**BILLYARD AVE DEVELOPMENTS PTY LTD ATF BILLYARD AVENUE DEVELOPMENT TRUST V  
CITY OF SYDNEY COUNCIL**

**21C Billyard Avenue, ELIZABETH BAY**

**JOINT TOWN PLANNING & URBAN DESIGN EXPERT'S REPORT**

**September 2024**

**Figure 1:** Western elevation – Billyard Avenue building

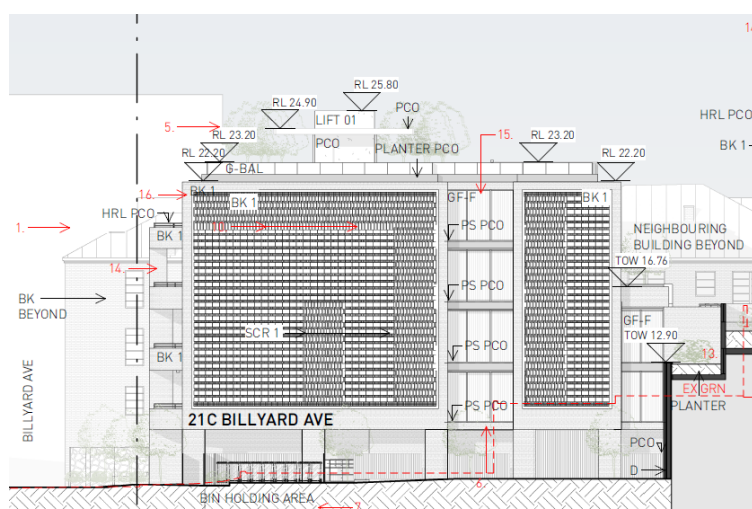
- (d) *At the Billyard Avenue frontage, the building does not adequately present as four storeys to the street with the upper-level setback to be visually less prominent between the adjoining three and four storey buildings as required by provision (4) at section 4.2.1.1 and section 4.2.2.2 of the SDCP. There is neither a setback or change in façade detailing and materiality at the top level to address this.*

15. The amended plans at Appendix B have incorporated façade detailing changes to the western façade of the Billyard Avenue building so that the upper level (fifth floor) is differentiated and less prominent from the lower four levels along this façade (see Figure 1 below). This serves to break down the perceived scale of the facade.

16. The experts agree that the amended plans at Appendix B satisfactorily address particular (d) above.
